Wireless Controller And Controller Cover Assembly No Longer Available

All freshwater and saltwater wireless models.

40652

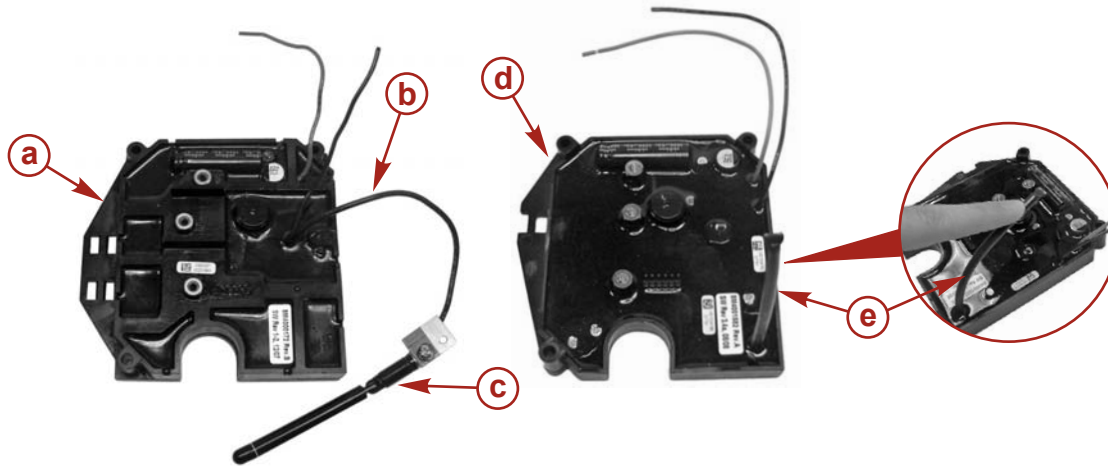
Wireless controller M899694T is no longer available. Additionally, freshwater wireless cover assembly M889266T and saltwater wireless cover assembly M899863T will no longer be available after current stock is gone.

- a** - Wireless controller (old design)
- b** - Wireless controller antenna wire (old design)
- c** - Wireless controller antenna (old design)
- d** - Wireless controller (new design)
- e** - Wireless controller antenna (new design)

- a** - Wireless cover assembly (old design)
- b** - Wireless cover assembly antenna hole (old design)
- c** - Wireless cover assembly (new design)

If the wireless controller requires replacement, use the existing cover assembly with the modifications described below.

1. Remove the wireless controller cover assembly and the defective controller.
2. Cut the antenna wire attached to the defective controller. Do not remove the antenna from the cover assembly. The antenna prevents water intrusion through the antenna hole.

3. Install a new controller and connect the battery meter. For assembly instructions, refer to the **Wireless Service Manual**.
4. Push down on the flexible antenna with one finger and slide the controller cover over the controller. Ensure the controller cover is secure.

Replace the wireless cover assembly if needed. If the controller cover assembly is no longer available, replace the wireless controller and controller cover assembly.
